REF. NO.: 91A/1483 CERTIFICATE NO.: 16276 B
 PROPOSAL: Bungalow + Septic tank
 LOCATION: Cotterelly Tallaght
 APPLICANT: Mr & Mrs T. Mahon

Proposed bungalow and septic tank at Castlekelly, Tallaght, Co. Dublin for Mr. T. Mahon.

Report of the Dublin Planning Officer, dated 7 November 1991 *15/12/91*

SITE PLAN

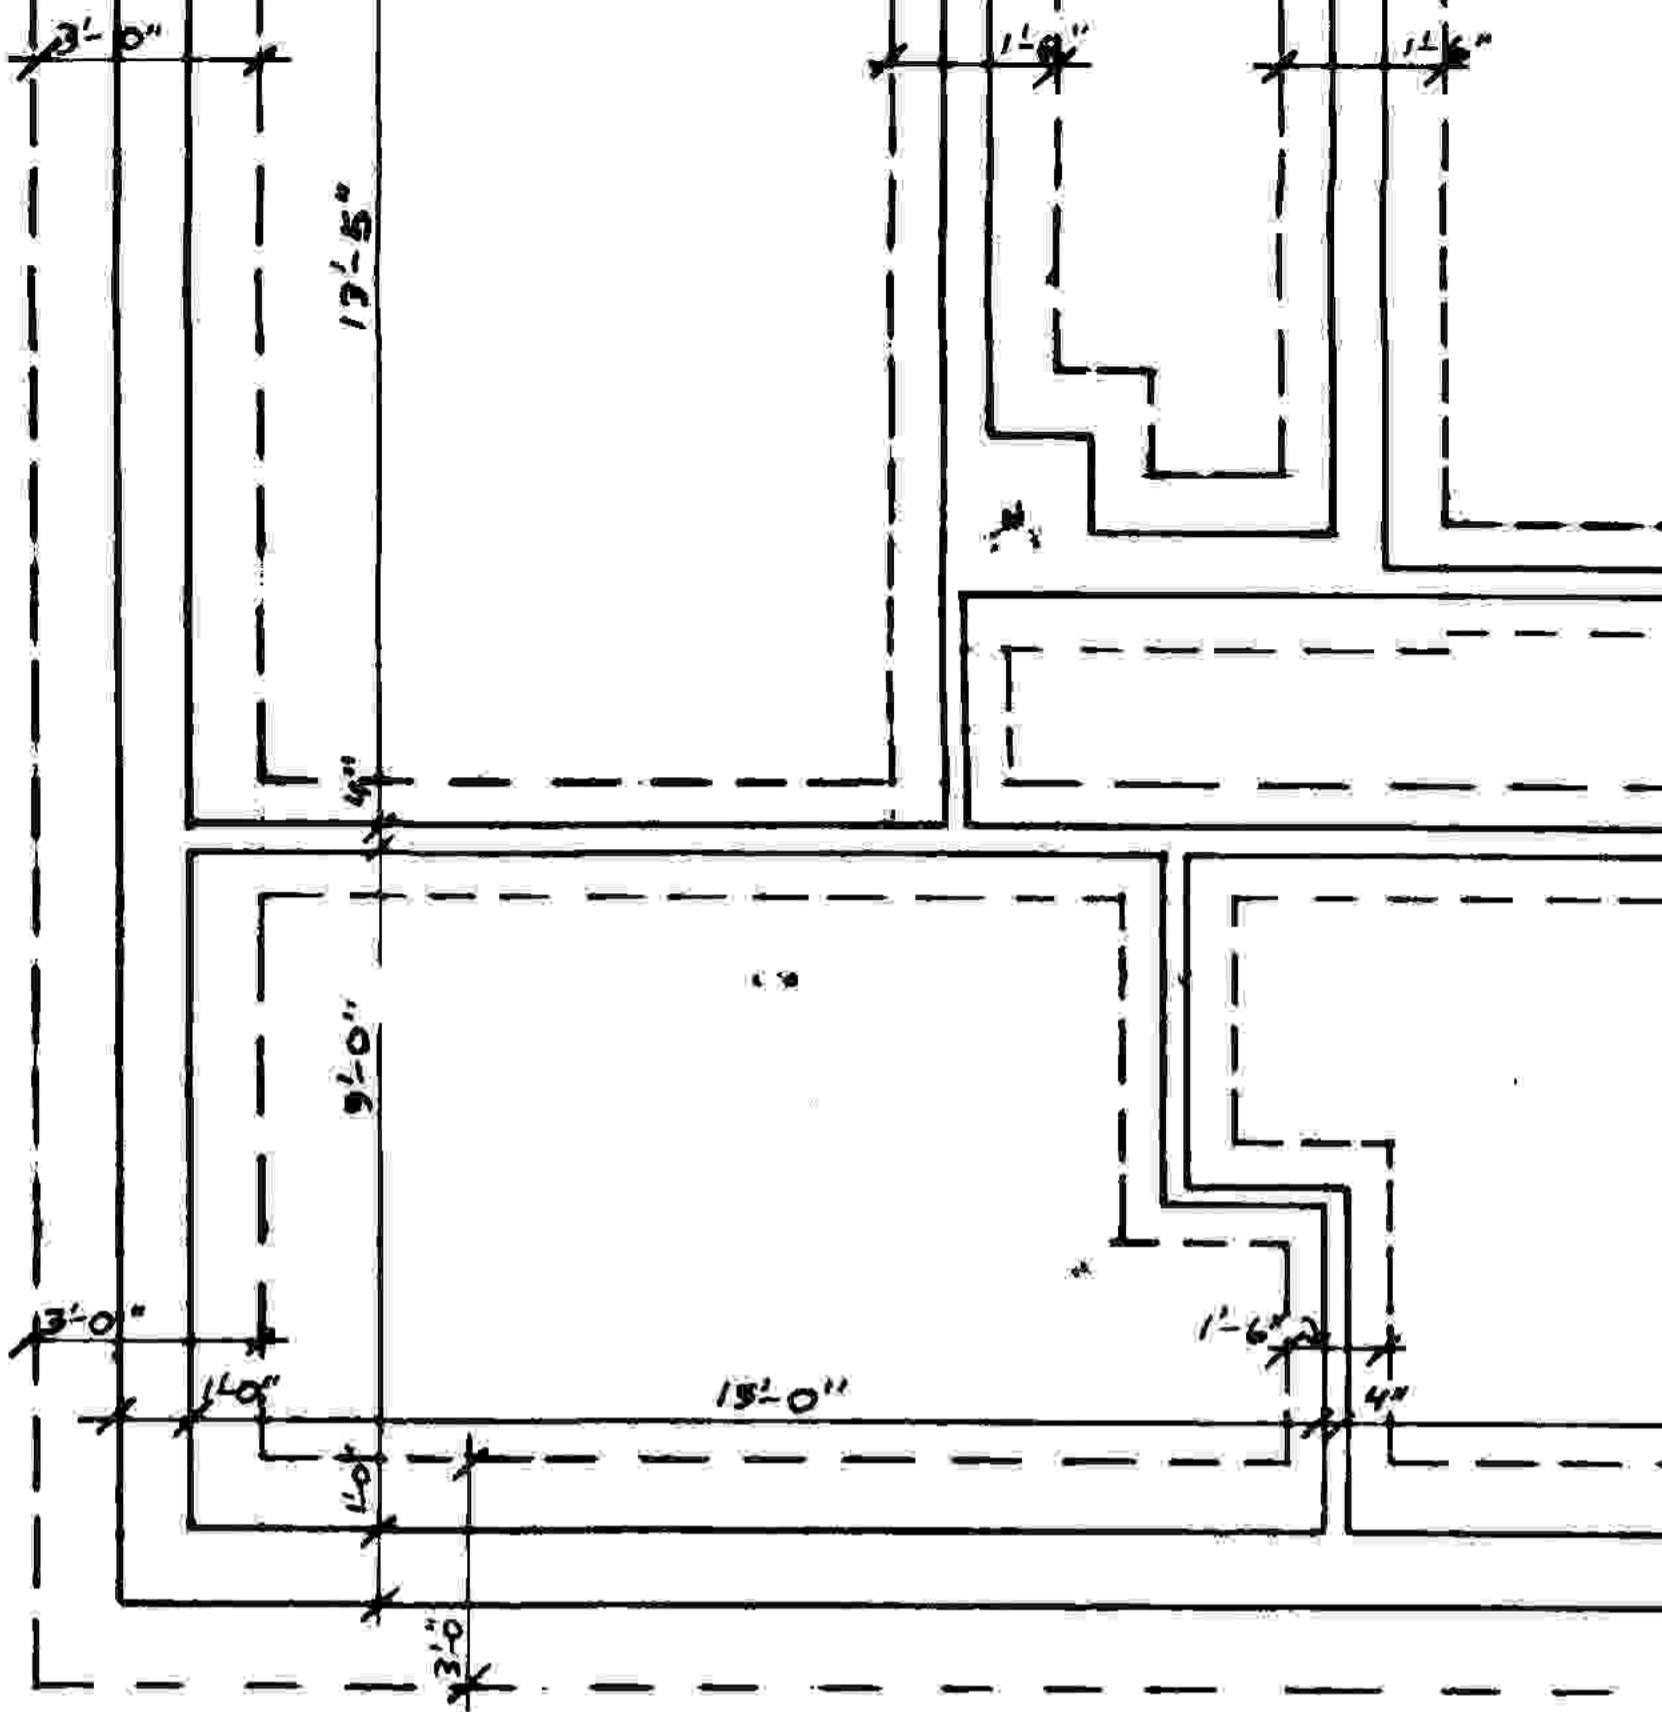
1. Evidence to indicate suitability of soil for ~~the~~ this treatment & disposal of septic tank effluent has not been provided.
2. Contours of site not shown.
3. Distance between proposed well and percolation area is unacceptable.
4. Location of adjoining septic tank and percolation area not indicated.
5. Evidence to indicate suitability of water supply not provided.
6. Location of adjoining wells not shown.
7. Area of site is inadequate to accommodate a well and septic tank drainage system in compliance with Dublin Co. Council distance requirements

The proposed access location is hazardous because of very restricted sight distance northwards. In order to provide maximum sight distance the access would need to be moved southwards and set back on the bend with the boundary also set back along the vision splays. This would still not quite meet the required standards.

1. Access to be located 25 metres south of the position shown on the lodged plans.
2. The boundary of the site shall be set back 3 metres from the edge of the existing carriageway. The strip between edge of carriageway and boundary to be levelled and grassed to County council Standards. This work to extend from the north end of the site to 28 metres south of the revised access location.
3. All stormwater shall be disposed of to soakpits or natural watercourse within the site and shall not discharge onto the public road.
4. The gradient of the access shall not exceed 2.5% over the last 6 metres of approach to the public road.
5. Entrance gate to be recessed 1.5 metres from the new boundary with wing walls splayed at 45°.
